UNITED STATES PATENT AND TRADEMARK OFFICE

APPLICATION NO.	FILING DATE	FIRST NAMED INVENTOR	ATTORNEY DOCKET NO.	CONFIRMATION NO.
10/764,380	01/22/2004	Cheng Youn Lu	21676-07366	1505
758	7590	08/16/2004	EXAMINER	
FENWICK & WEST LLP SILICON VALLEY CENTER 801 CALIFORNIA STREET MOUNTAIN VIEW, CA 94041			RODRIGUEZ, ARMANDO	
			ART UNIT	PAPER NUMBER
			2828

Office Action Summary

DETAILED ACTION

FIG. 3

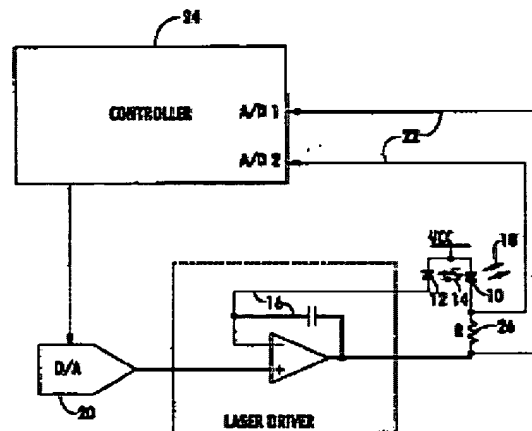
Figure 3 illustrates a dual loop control circuit for controlling the extinction ratio during modulation of the laser having a laser diode (10), an automatic power control (APC) loop (16), a monitoring diode (12), a digital-to-analog converter (20) and a controller (24), as described in paragraph [0020] to [0025]. In figure 2 the operation of the control circuit of figure 3 is illustrated, where the circuit determines all of the required

variables to determine the extinction ratio of the laser as illustrated the efficiency is determined by the values of P_{avg1} , P_{avg2} and Bias1, Bias2, as described in paragraph [0025] to [0029].
